Service Bulletin

Subject: WHITE OR BLUE SMOKE FROM TAIL PIPE AFTER LONG IDLE PERIOD - (OIL CHANGE PROGRAM TERMINATION)	Bulletin No: 01-004/10
	Last Issued: 08/18/2010

- This bulletin supersedes the previous bulletin 01-004/10 issued on 01/07/10 and 02/17/10. The DESCRIPTION, INSPECTION PROCEDURE, PART(S) INFORMATION and WARRANTY INFORMATION have been revised.
- Changes are noted below in Red beside the change bar.

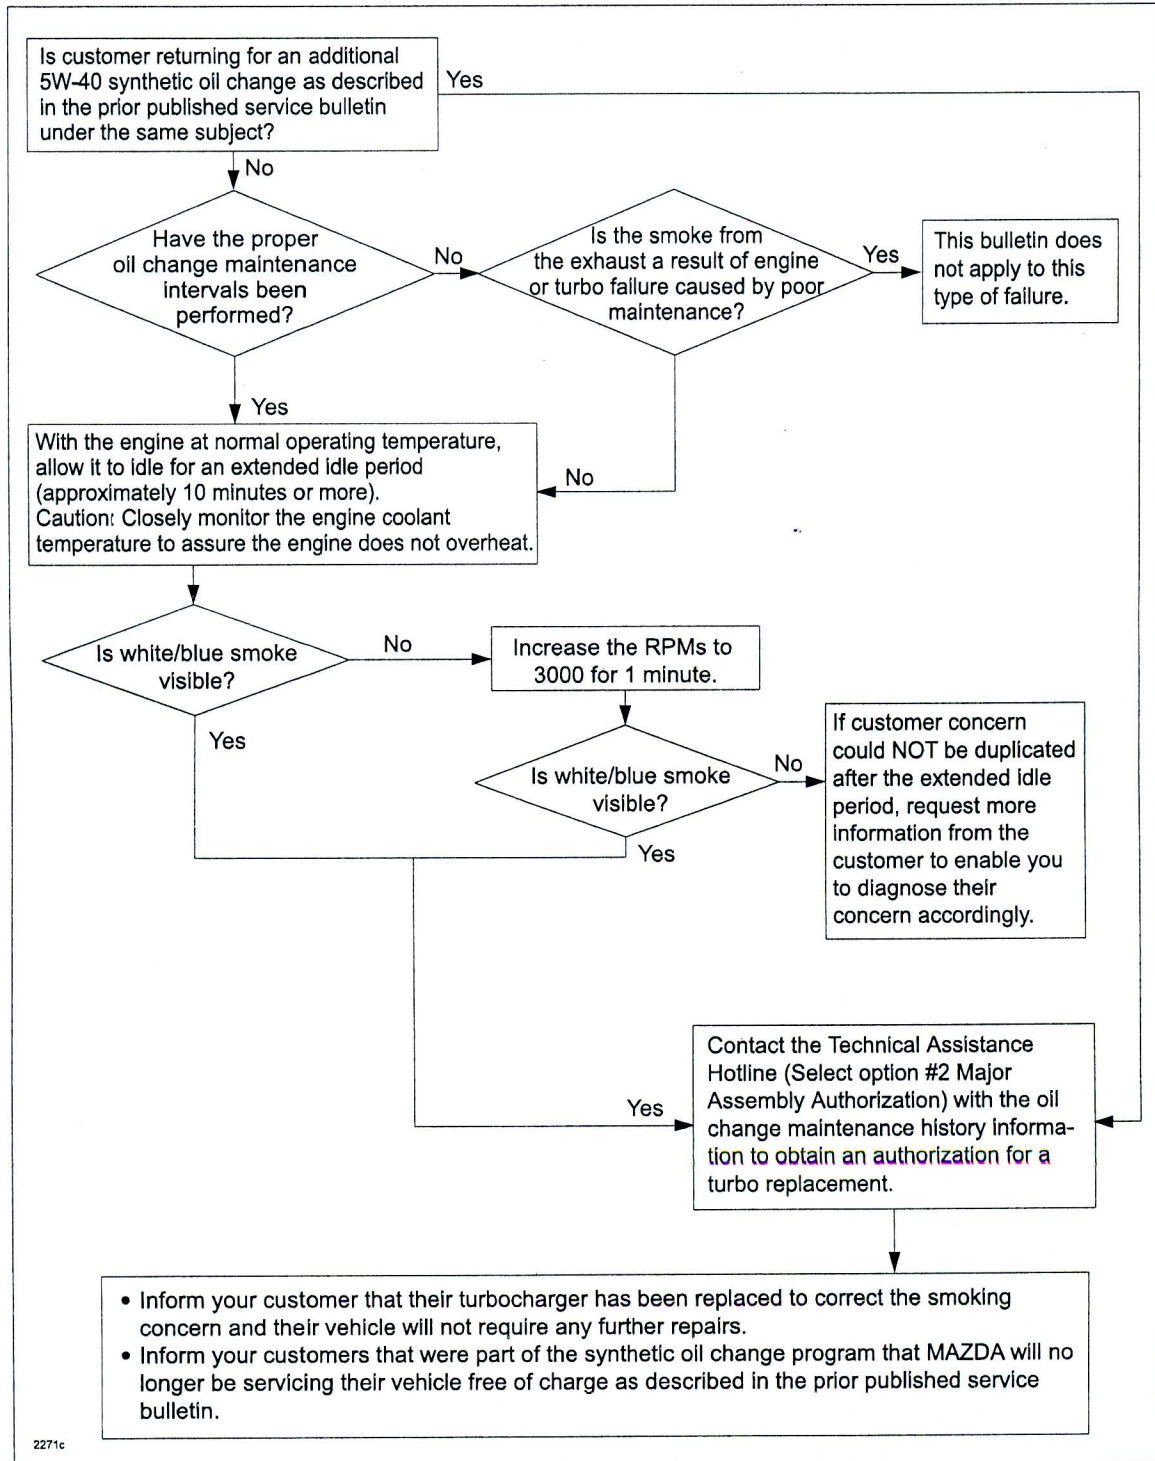
Some customers may experience white/blue smoke from the exhaust pipes after long idle periods or while driving at slow speeds in heavy traffic.

Customers having this concern should have their turbocharger replaced according to the following procedure.
